工程指示 / 要求簡箋(E.I.)

工程指示編號：EI/5619/23

工程名稱：將軍澳日出康城 11

工程項目：幕牆 修補方案用配件 (M16) 則師改倉位

RM3—Typical Missing

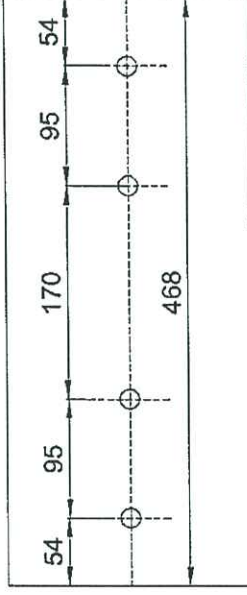
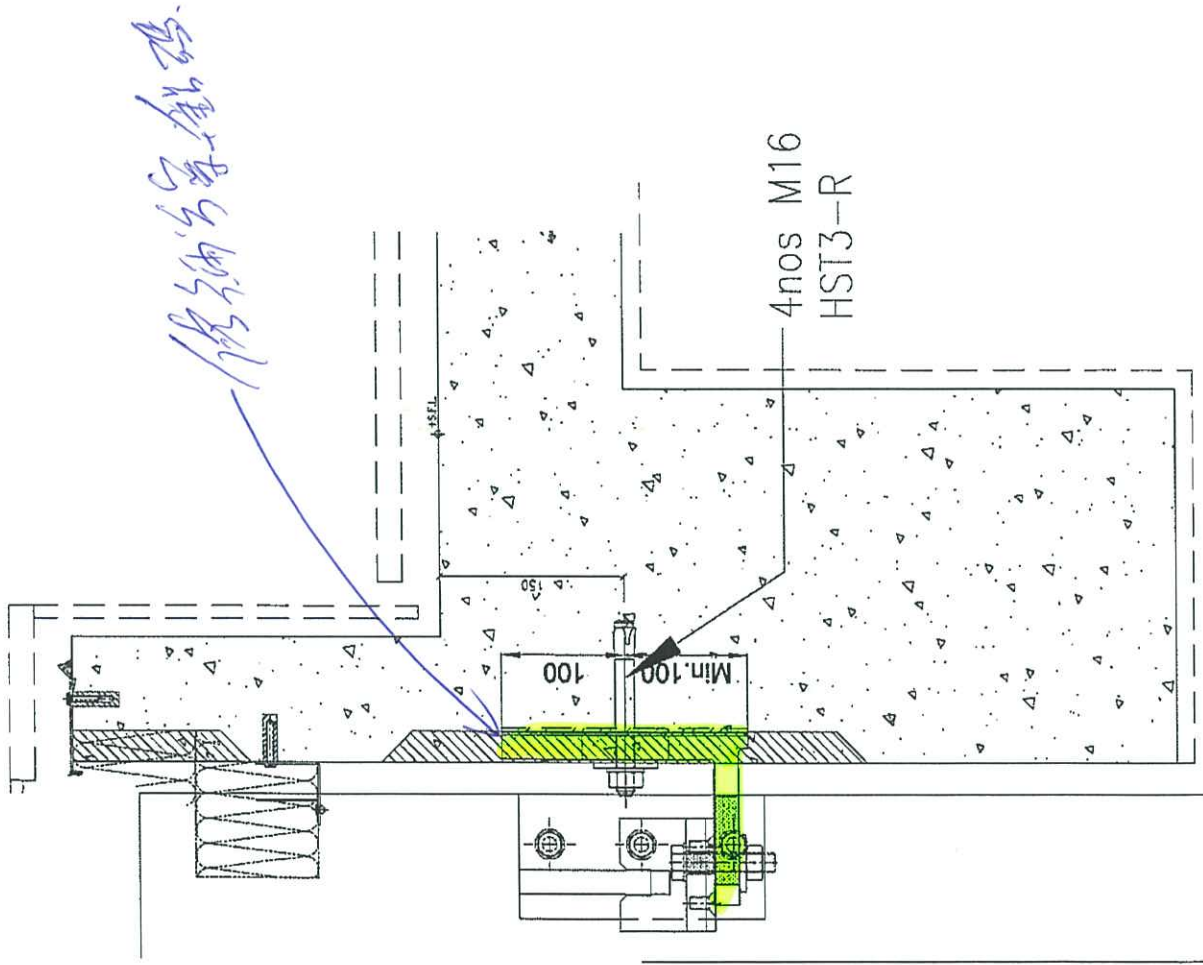
舊的
不是
給桿
改

① 原位置的給桿
會撞正料。

↳ 給桿要介 (2支)

② AM16⁺ 做 remedial

↳ 修補架

J858单元幕墙墙身挂码位置图(T1)

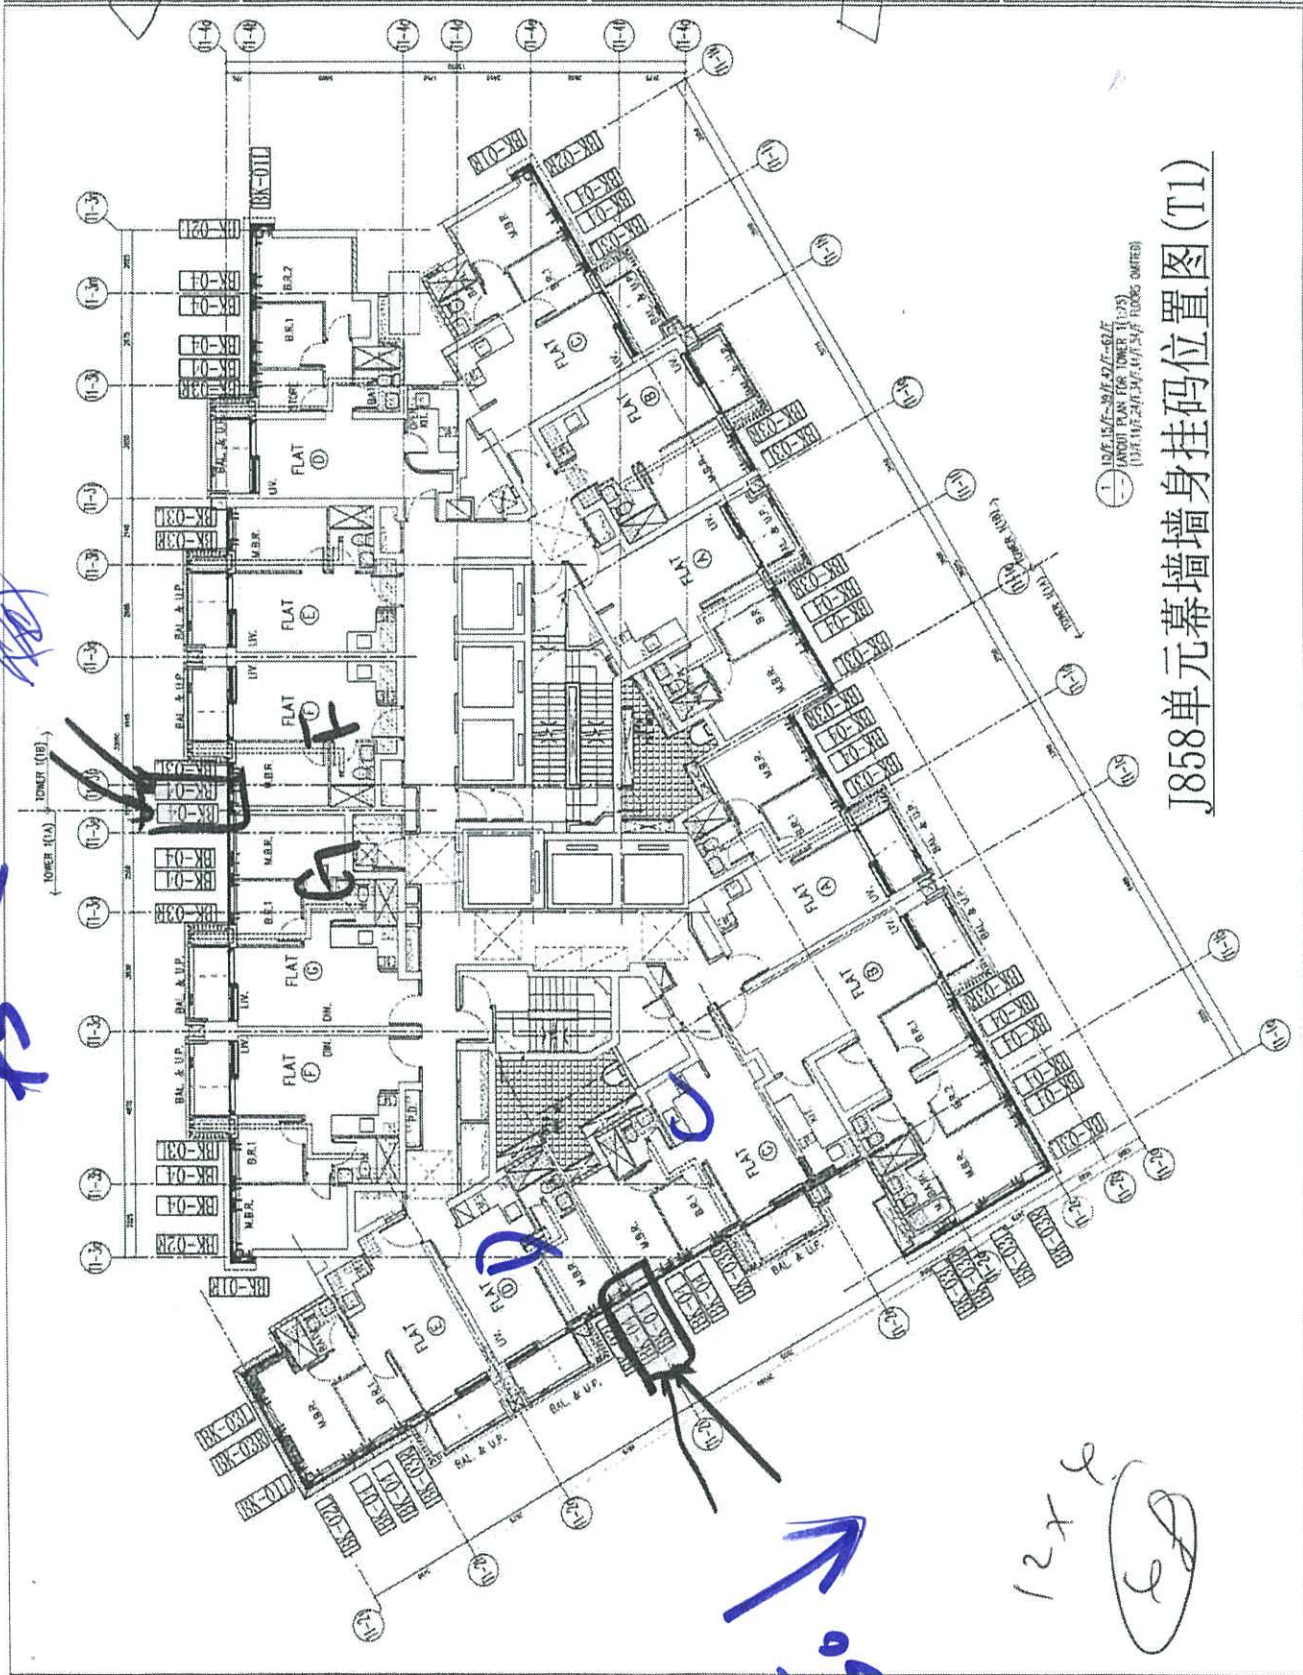
12x6
 6

75 ←

→ 12x6

J858单元幕墙墙身挂码位置图(T3)

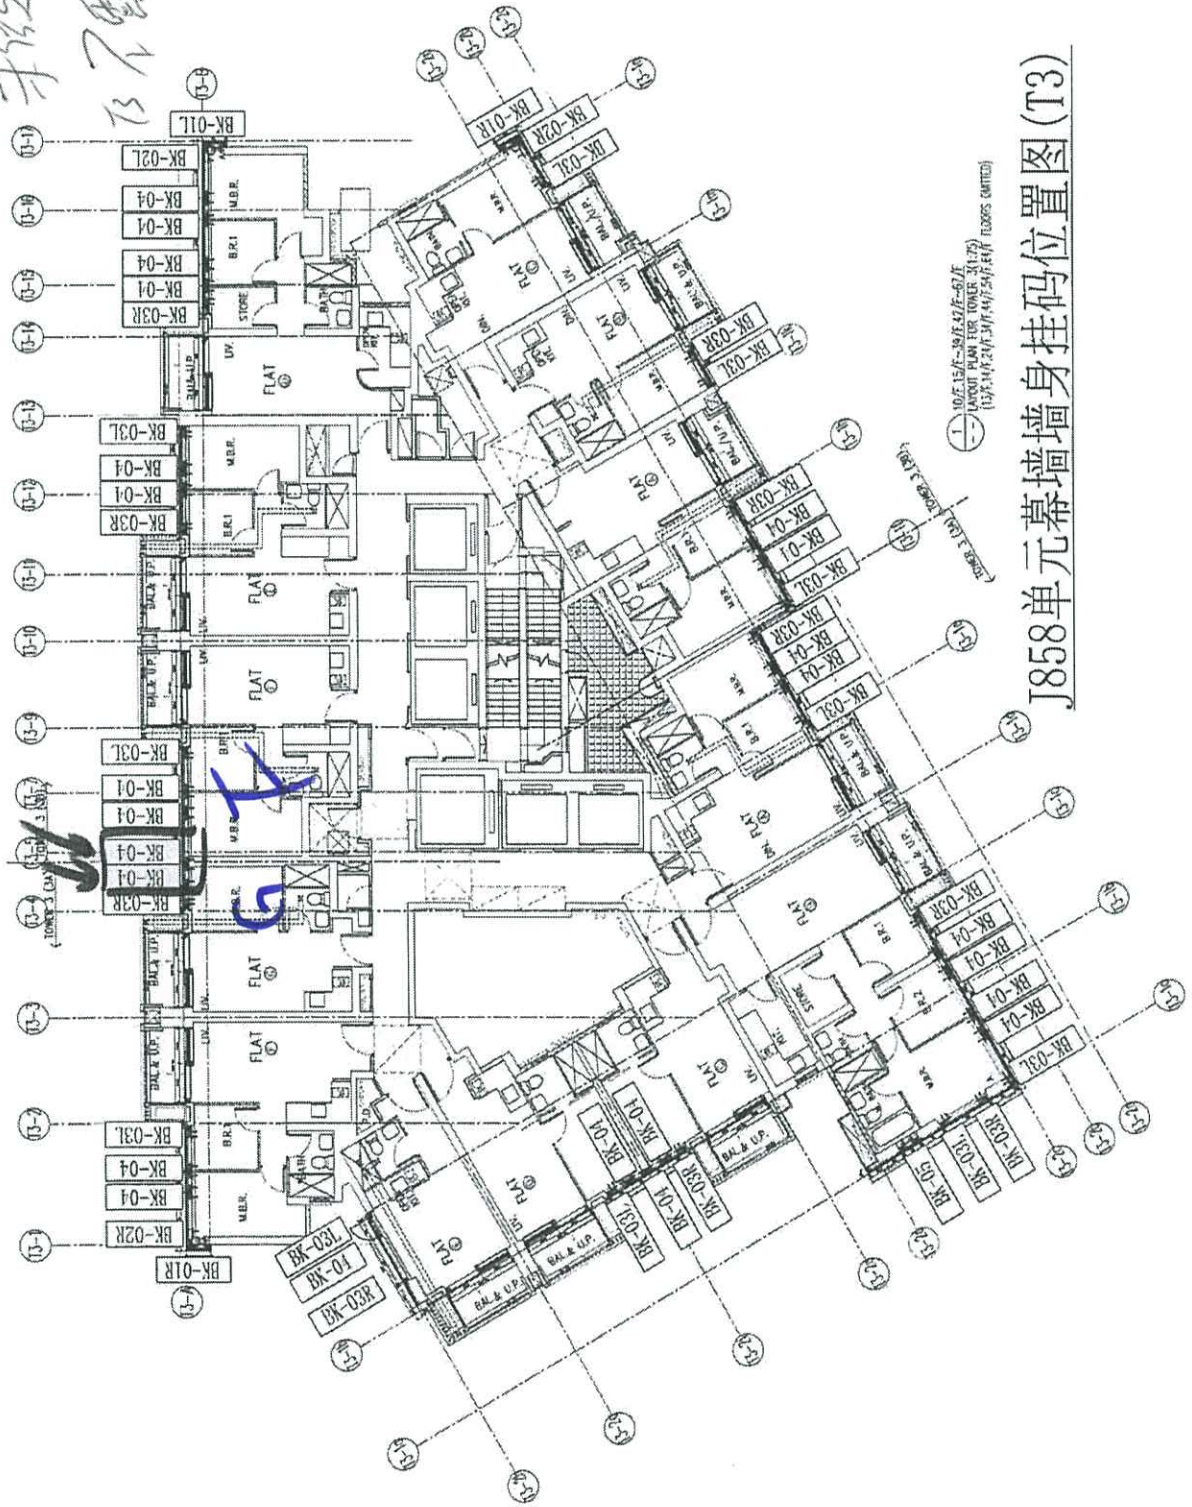
12x2
 20

87.5

手改的
B7 不修改

→ 87.5

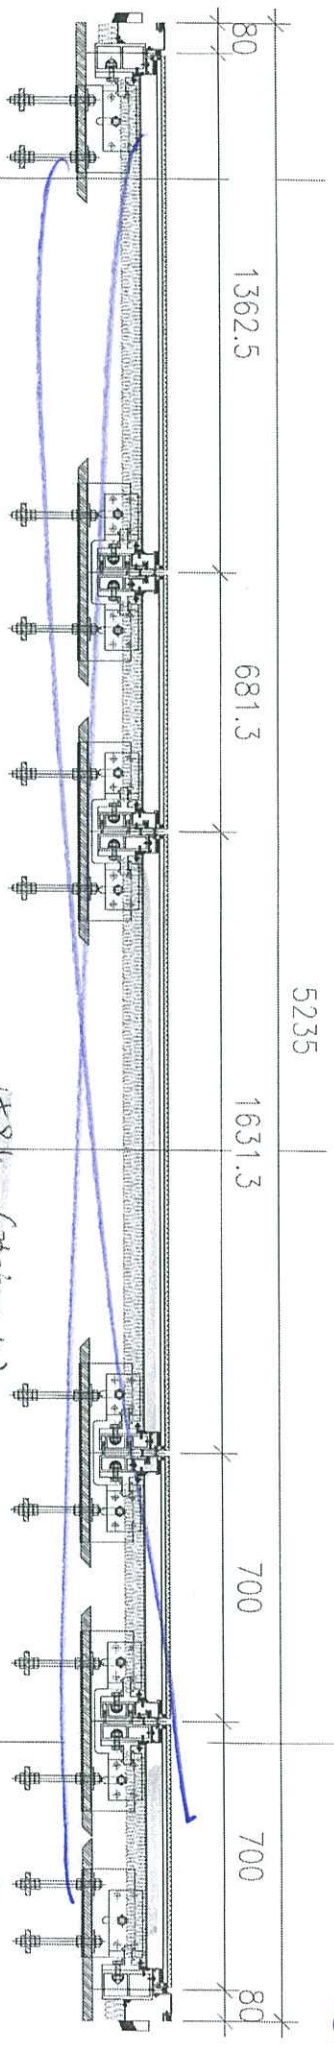
Original.

1584 (稍短点)

663 (稍短点)

New

75.5L 返回

5L ←

5L ←

1556.3 ✓

700 ✓

675 ✓
